Form 3160-3 (June 2015)			OMB No	APPROVED . 1004-0137		
UNITED STATES			Expires: Jar	nuary 31, 2018		
DEPARTMENT OF THE IN			5. Lease Serial No. NMNM97127			
BUREAU OF LAND MANA APPLICATION FOR PERMIT TO DI			6. If Indian, Allotee or Tribe Name			
APPLICATION FOR PERMIT TO DE			o. If Indian, Anotee of Thoe Name

7. If Unit or CA Agreement, Name and No.			
	EENTER					
	her	_	8. Lease Name and V			
1c. Type of Completion:   Hydraulic Fracturing	ngle Zone	Multiple Zone	HONEY BUN 6 FEI	D COM		
2 Name of Occurrent			727H

Eddy County, NM (NAD 83 NME) Honey Bun 6 Fed Com #727H

# COA

850' FNL 1598' FEL Section 6 T-26-S, R-27-E Proposed Wellbore Design B KB: 3,317' GL: 3,292'

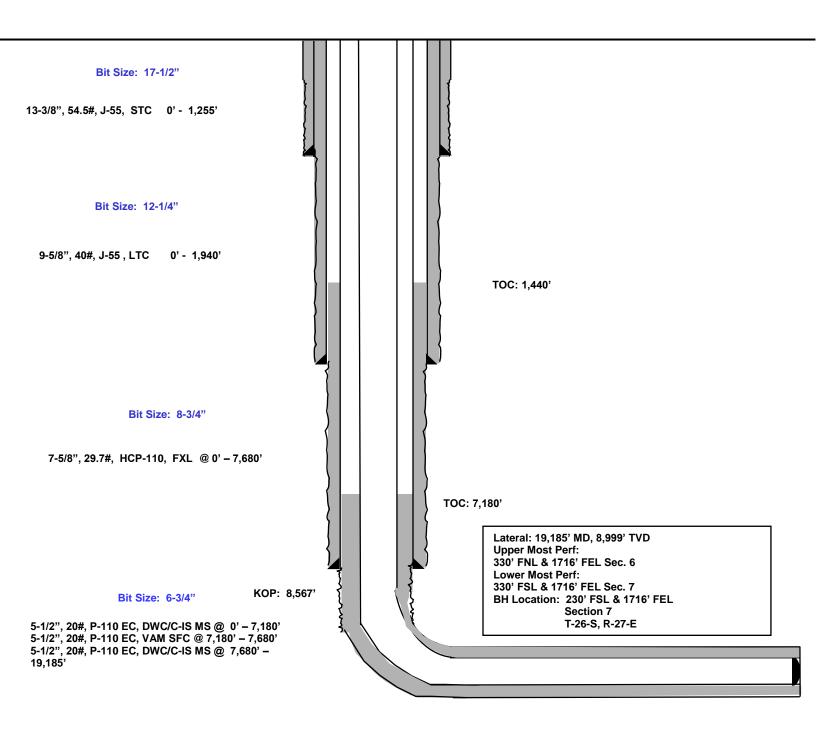
Operator is only approved for Design A. Design B is not to be utilized. If Design B is needed or any other change, please submit a NOI sundry to make the changes.
